**City of Cleveland Heights
Planning Commission**

STAFF REPORT FOR THE FEBRUARY 9, 2022 REGULAR MEETING

SUBJECT: Proj. No. 21-17 Flaherty & Collins, C-2X Multiple-Use, Cedar-Lee-Meadowbrook redevelopment, bounded by Cedar Rd., Lee Rd., and Meadowbrook Blvd., and is bisected by Tullamore Rd. (PPN 687-06-009, 687-06-010, 687-06-013, 687-06-088, 687-06-089, 687-06-090, 687-06-091, 687-06-092, 687-06-093, 687-06-094, 687-06-095, 687-06-096, 687-06-159 and 687-08-001) per Zoning Code chapters 1111, 1115, 1131, 1151, 1153 1161, 1165, 1166.

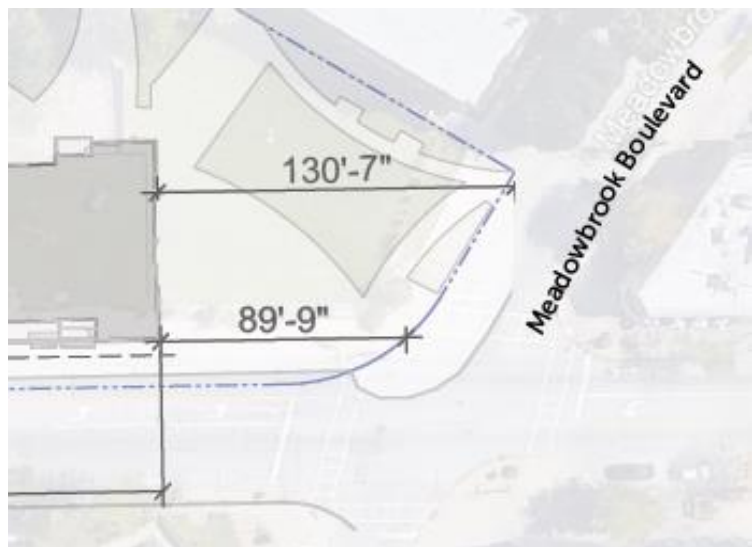
Staff recommends approval by the Planning Commission of a Conditional Use Permit for Meadowbrook Park, with the following conditions:

1. Per Zoning Code Section 1131.14(b), the Planning Commission establishes a permitted setback for the Meadowbrook Building off of Meadowbrook Blvd. to range from 89'9" to 130'7" as shown on the Dimensioned Site Plan;
2. Should the park plan be modified to include an outdoor play area the plan will need to be reviewed by the Planning Commission and per Zoning Code Section 1153.05(b), the Planning Commission may require a park to fence in the outdoor play area to minimize traffic hazards and buffer neighboring properties;
3. Details of all proposed fences shall be part of the Final Landscape Plan;
4. A Final Landscape Plan shall be provided, as specified in Zoning
